INITIAL FIRE SAFETY INSPECTION REPORT

GMS Composite Knitting Ind. Ltd. (New Building)

RSC ID: 24141

Date: 24-May-2021 and 31-May-2021

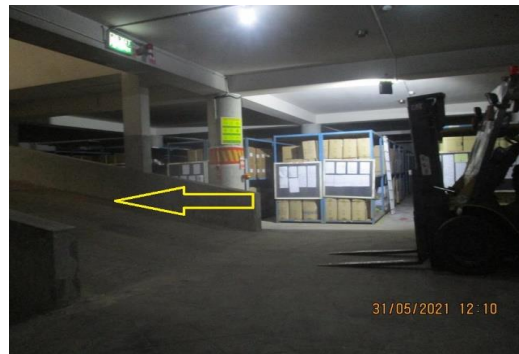
F-4	Fire Rated Construction	Chemical storage area is not properly separated by fire-rated construction with general store. Location: Basement of building 07.	Separate the chemical storage room by minimum 4-hr fire rated construction. Seal all penetrations and protect the openings to maintain the required fire separations. Keep 16-points MSDS of all chemicals in the storage area. ** As per BNBC, chemical storage room shall be Type-1 construction. Follow section-2.13 and Table 3.2.1 of BNBC-2006 for the guideline.	Within 3 months
-----	-------------------------	---	---	-----------------

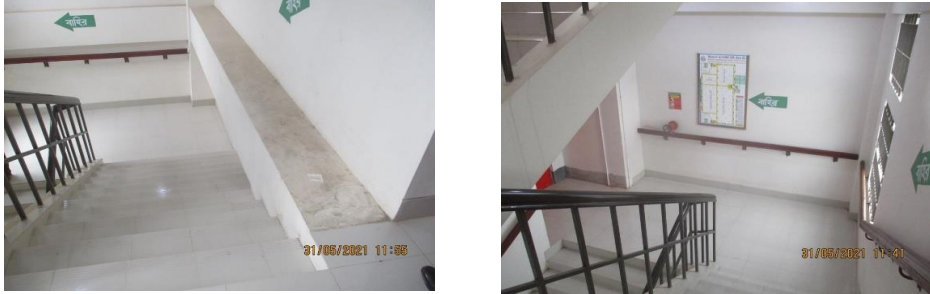
F-5	Means of Egress	Exits are not remotely located from each other of the basement floor. Location: building 7(basement)	Specify appropriate upgrade based on conditions:- 1. Modify exit arrangement to meet ACCORD standard 6.6.6. OR 2. Provide additional exit(s) to meet ACCORD standard 6.6.6.	Within 3 months
-----	-----------------	---	---	-----------------

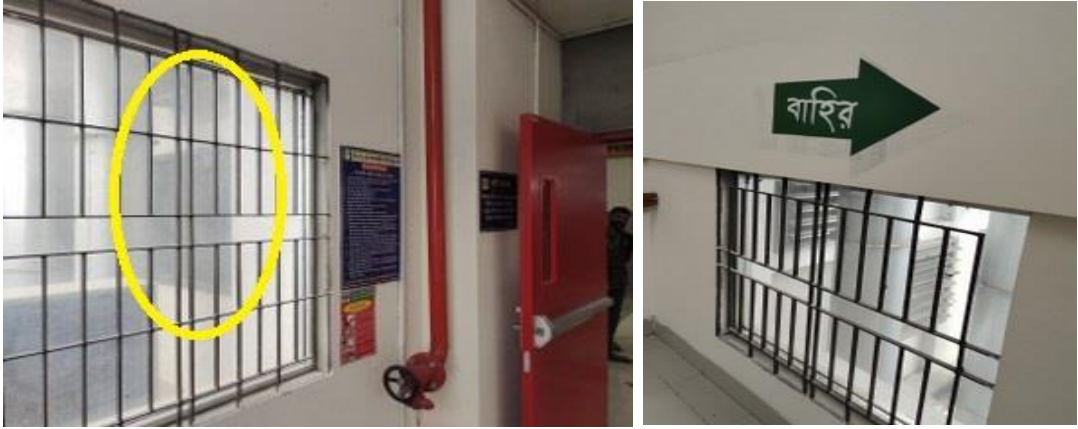
F-32	Means of Egress	Landing are not provide both side of doors used in the means of egress. The door installed on the discharge point is very narrow comparing to stair width which increase the possibility of bottlenecking of the discharge system. Location: Ground floor - stair -3 at building- 9 (washing).	Landing shall be provided both side of doors of the means of egress. Modify the width of the door.	Within 3 months
